*Technical Memo 2016-0715*  
*July 2016*

## Evaluation for Potential Unreasonable Impacts: Needmore Water, LLC, Well D Permit Application

Brian B. Hunt, P.G., and Brian A. Smith, Ph.D., P.G.

**Figure 1. Graphical presentation of drawdown versus time from the Needmore pumping alone at the Amos observation well (assuming Table 1 parameters). Note most of the drawdown occurs within the first year.**

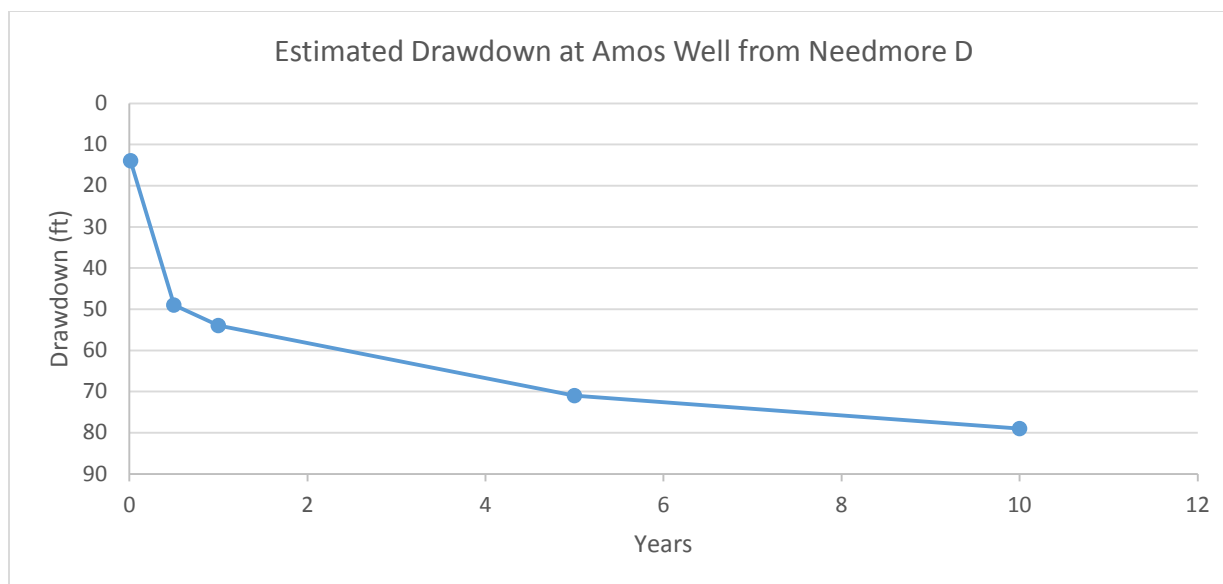
Using the aquifer parameters derived from the aquifer test (**Table 1; Appendix A**), the AS staff estimate the additional drawdown from the Needmore pumping over time in **Figure 1**. For the evaluation, AS staff choose drawdown from pumping during a 7-year period. This period was chosen to be representative of a severe drought when little recharge occurs, and capture is constrained. The results of the estimated drawdown at the Amos Well due to Needmore pumping is about 75 ft after 7 years (**Figure 1**).

**Figure 2. Potential Index Well Diagram and Compliance Levels**

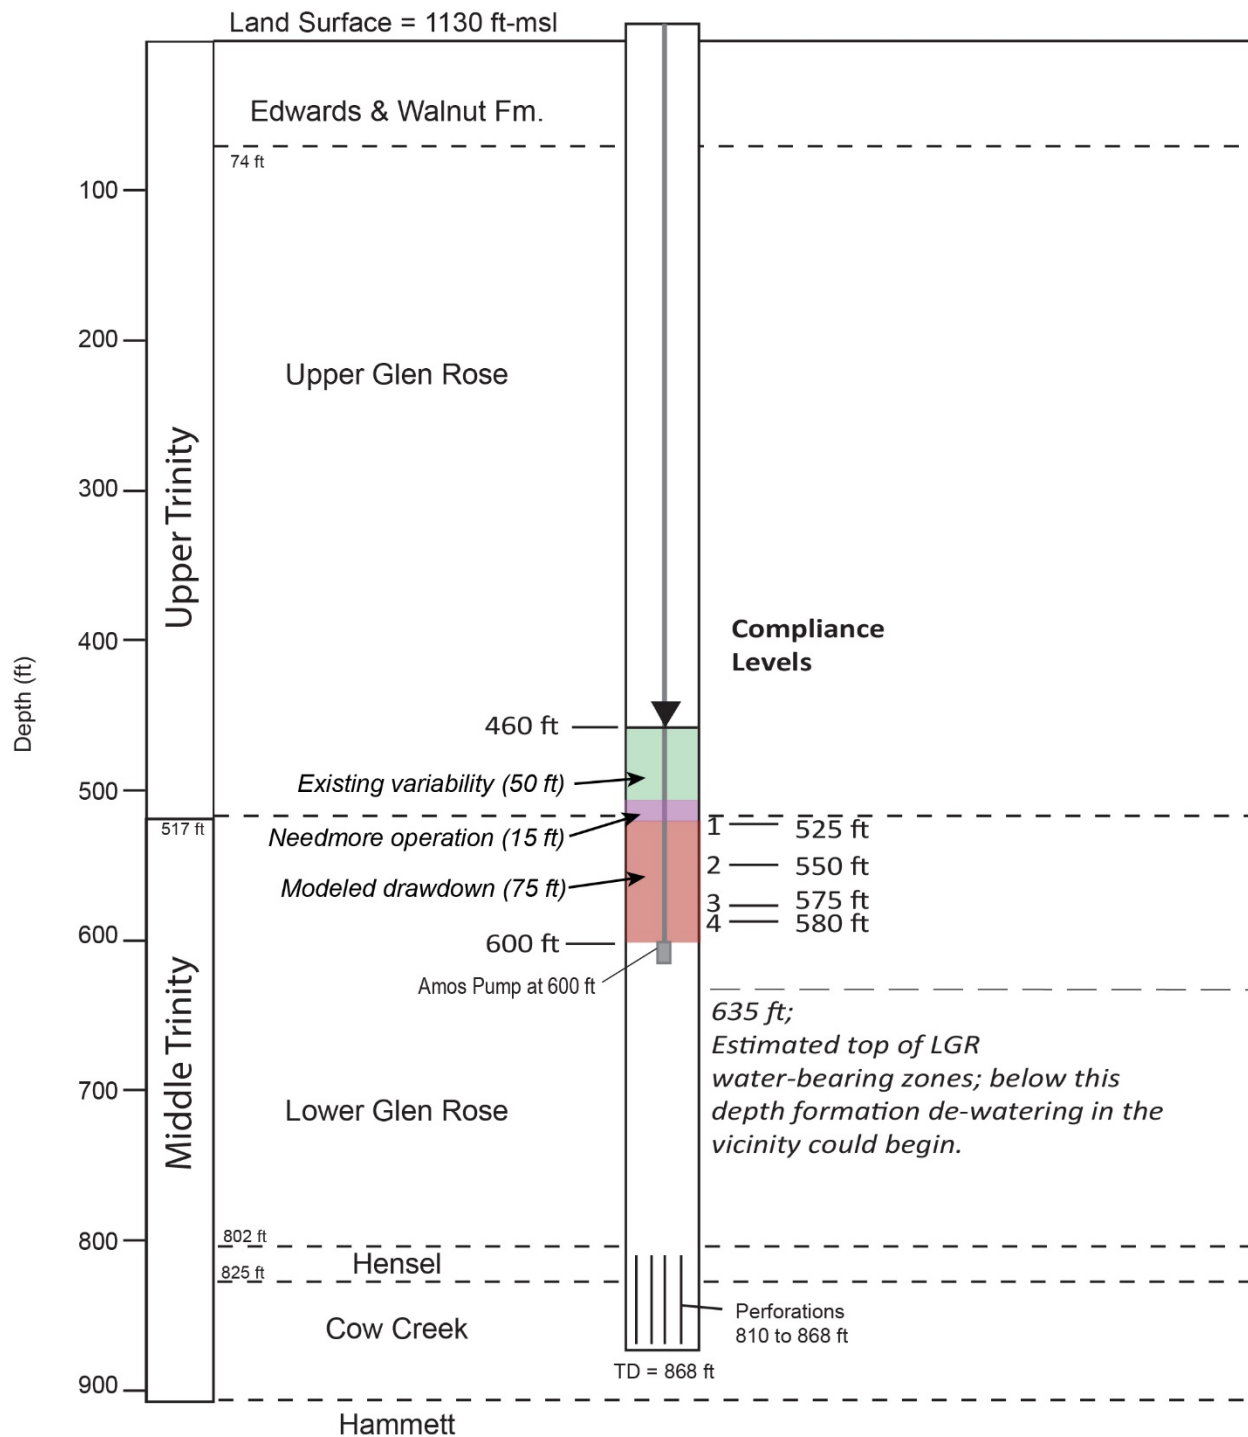
**Table 3** presents a summary of the specific compliance levels derived for the Amos Well. **Figure 2** is a graphical representation of the Amos Index Well and the corresponding compliance levels. Compliance levels were set after considering natural water level variability (Table 2; 50 ft) and also the observed short-term operational effects of pumping from the Needmore Well (~15 ft). Thus, this allows for up to about 65 ft of variability below the average water level before crossing the first compliance level threshold. **Figure 3** is a conceptual diagram showing how each compliance level is distributed over depth and time.

Compliance Level	Description	depth to water (ft)	Note	Permit Action
1	Evaluation	525	Approximate top of Middle Trinity Aquifer as determined from geophysical logs.	District will conduct an evaluation of data to assess the actual impacts of pumping.
2	<u>Avoidance Measures</u>	550	This level is the mid-point between level 1 and 3 and is a sentinel level to begin curtailment measures in order to delay or abate further drawdown.	Temporary curtailment of <b>20%</b> off the baseline curtailment rate (BCR).
3	<u>Maximum Drawdown Allowable</u>	575	This level accounts for the drawdown from the Needmore Well D pumping for 1 year (~50 ft), after accounting for 65 feet of variability	Temporary curtailment of <b>40%</b> off the baseline curtailment rate (BCR).
4	<u>Unreasonable Impact to Existing Wells</u>	580	This level is deemed a reasonable pump intake level and below this level an unreasonable impact occurs to the Amos Well, and likely surrounding wells.	Temporary curtailment of <b>100%</b> off the baseline curtailment rate (BCR)
